Harbourside Shopping Centre

Submission to SSD 16_7874

Submitted to NSW Department of Planning & Environment
On Behalf of AAPC Limited (Novotel & Ibis Hotel)

February 2017 | P-17022

Figure 1: Existing view from RL 36.00 (Source: JBA VIA - Appendix C)

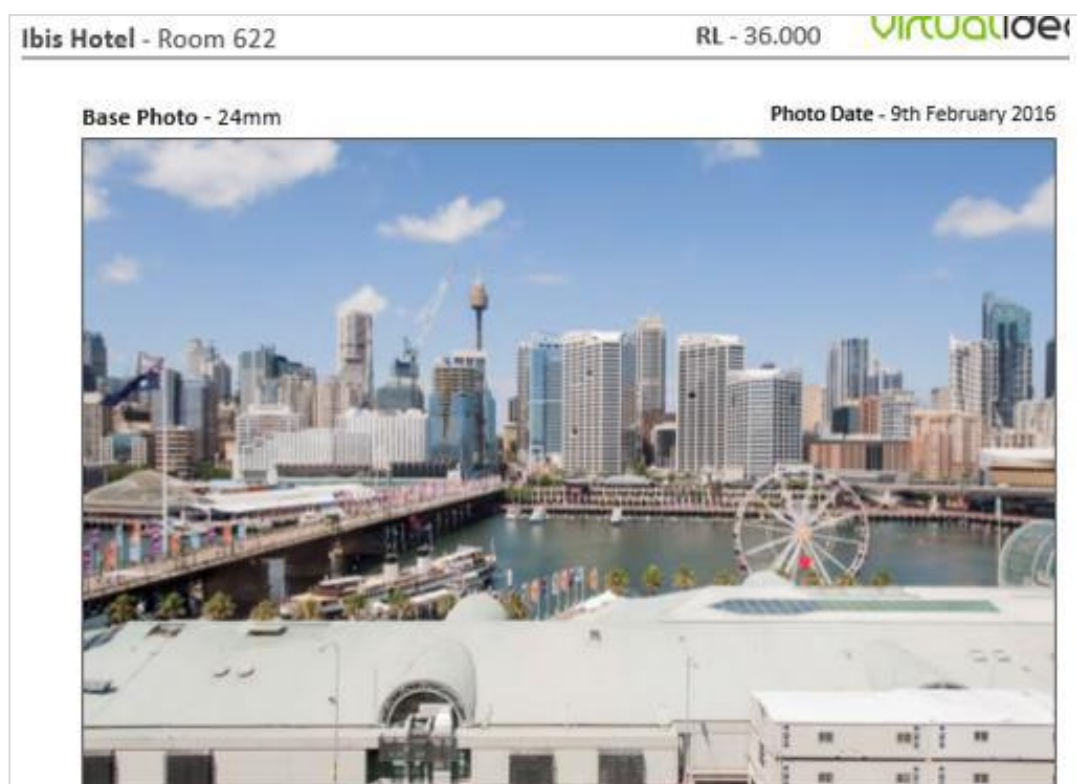
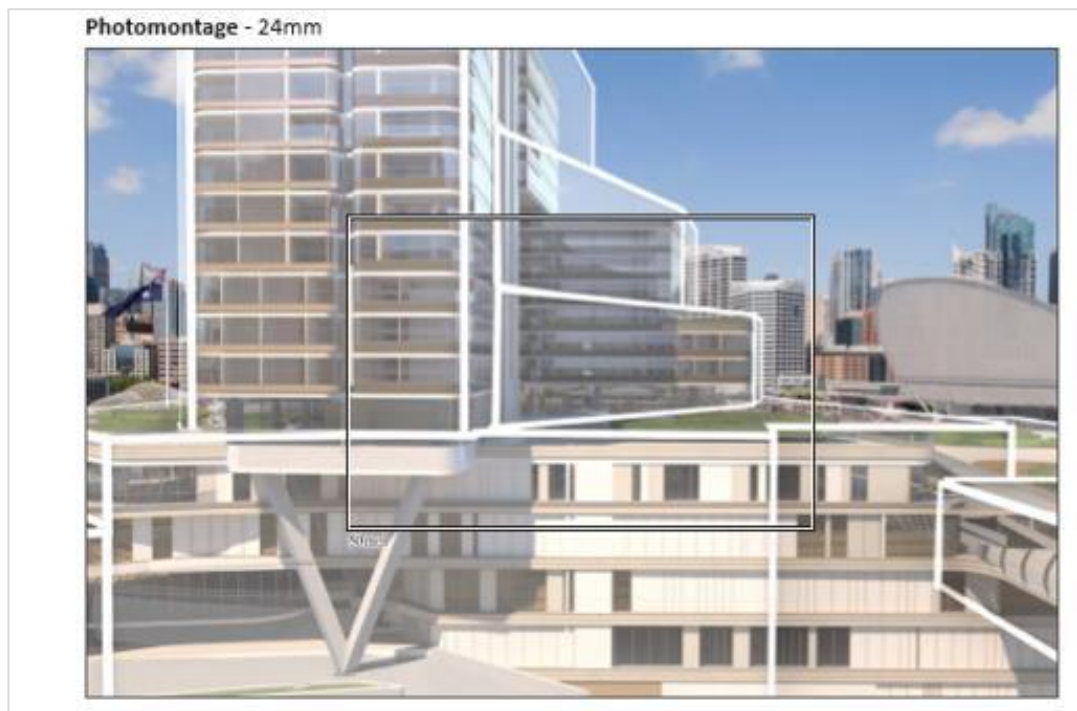
Specifically, the VIA indicates that existing water views from the Ibis Hotel from RL 36.00 (i.e. Level 6) will be severely impacted by the proposed redevelopment. Views of the Pyrmont Bridge would also be completely obstructed at this RL. Therefore, views of Darling Harbour and Pyrmont Bridge, from ground level up to level 6 would be severely affected. This is a significant number of hotel rooms which would have their views severely affected. Further, whilst the VIA provides that most views from RL 47.959 could be retained, no analysis of impact is provided between this RL (i.e. 47.959) and level 6 (i.e. RL 36.00).

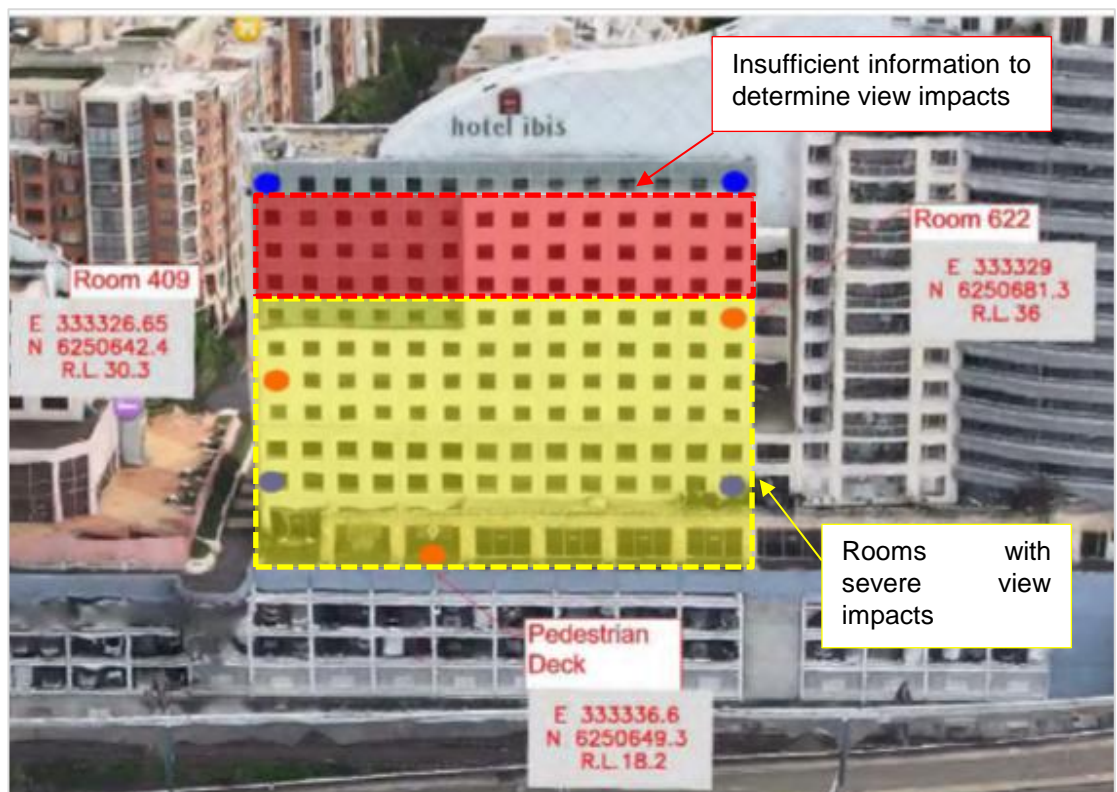
Figure 3: Extract from VIA with yellow highlighted area indicating hotel rooms below RL 36.00 which would have existing views of Darling Harbour and Pyrmont Bridge severely affected. Insufficient information is available in the VIA to determine the specific impacts within the red highlighted area, but they are likely to be substantial impacts (Source: JBA VIA - App C)

Figure 8: Proposed north easterly views from Novotel restaurant (Source: JBA VIA - App C)

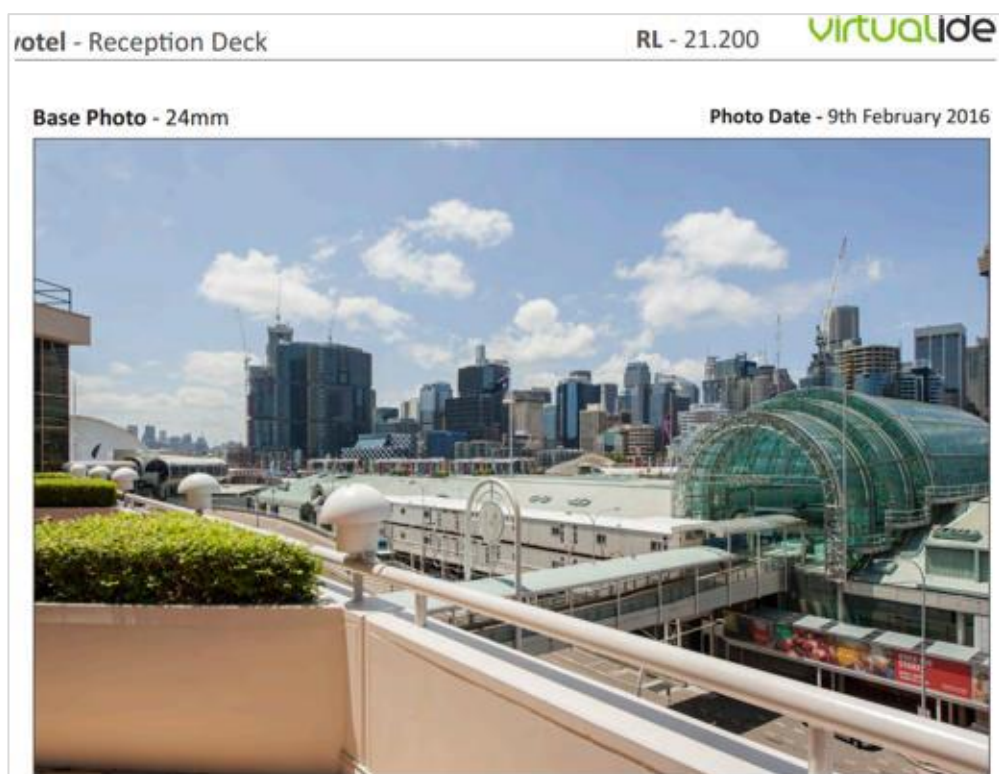
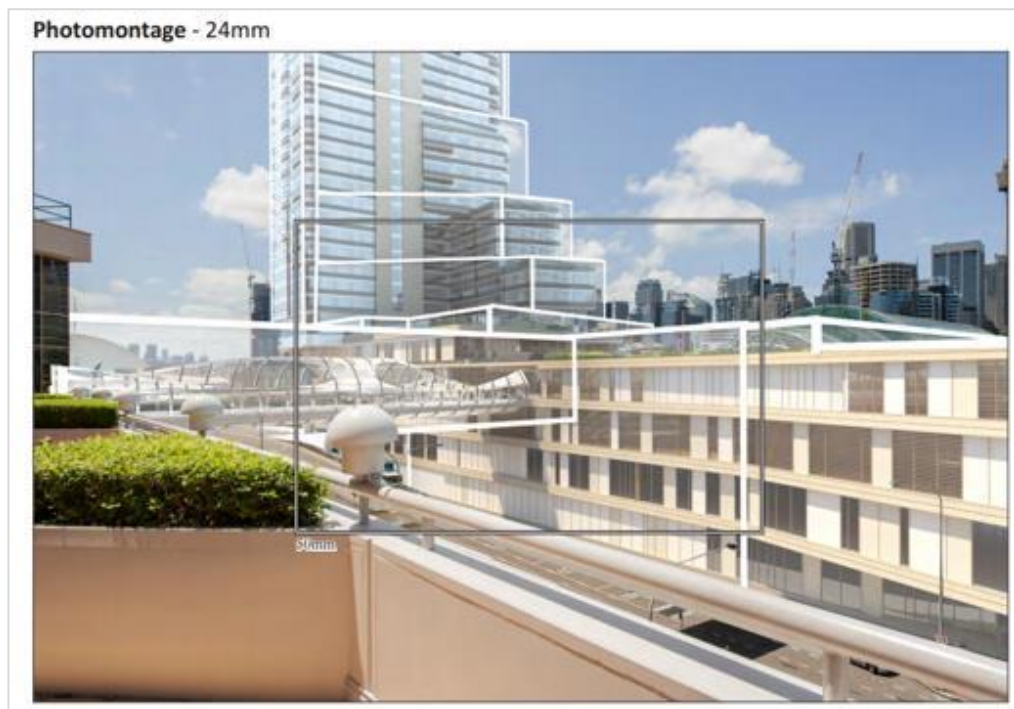
The VIA indicates views of the Sydney CBD skyline from the restaurant would be moderately affected. We are of the opinion any view impacts should be further analysed in a directly east facing direction (as provided in Figure 4). In our opinion, this view is of greater significance given it shows the Sydney Tower and its context in full. Further, it would allow an assessment of cumulative impacts associated with the ICC and the proposed IMAX redevelopment.

Figure 9: Photomontage for RL 36.150 with approximate loss of water views from Novotel outlined in yellow (Source: JBA VIA - App C)

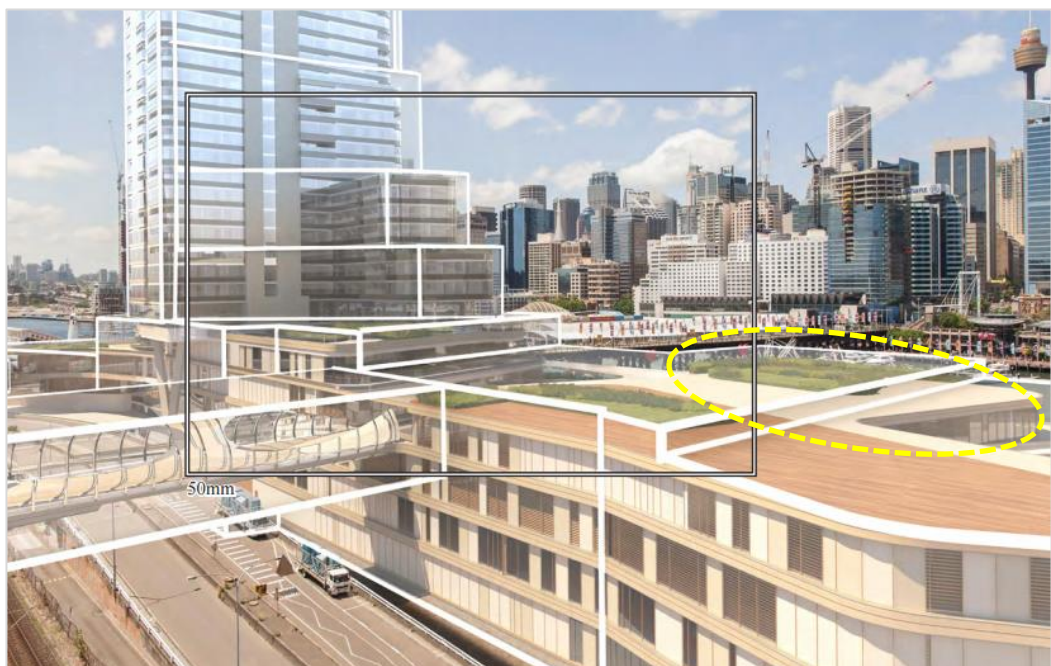
Similarly, photomontages prepared for RLs 34.093, 36.150 and 44.500 indicate moderate impact to existing water views (i.e. Darling Harbour) from the Novotel's east facing hotel rooms.
